DEVELOPMENT REVIEW BOARD - **HYDROLOGY SECTION**

DRB Project Number: 2021-005687 Hearing Date: **02-16-2022**

Project: **TRACT C, ALAMEDA WEST** zoned **MX-M** Agenda Item No: **14**

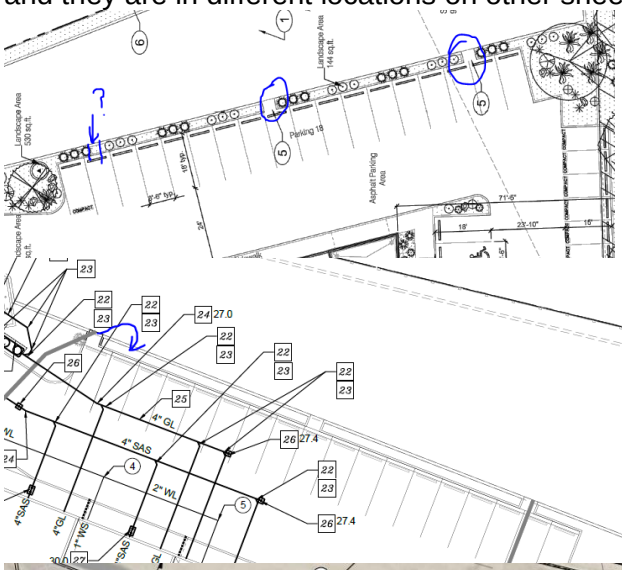
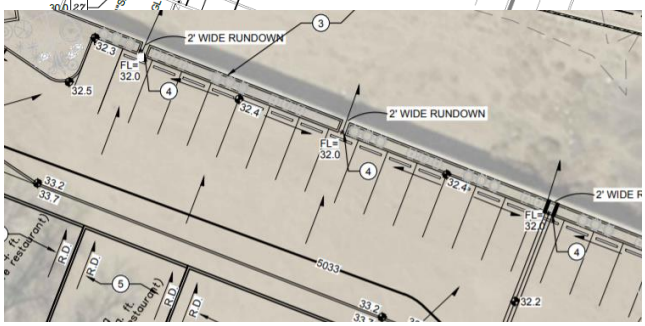
- Hydrology has an approved Grading & Drainage Plan.
  - Please ensure drainage features match what is on this.
  - The site shows two curb cuts on the landscape plan where there should be three and they are in different locations on other sheets.
  -
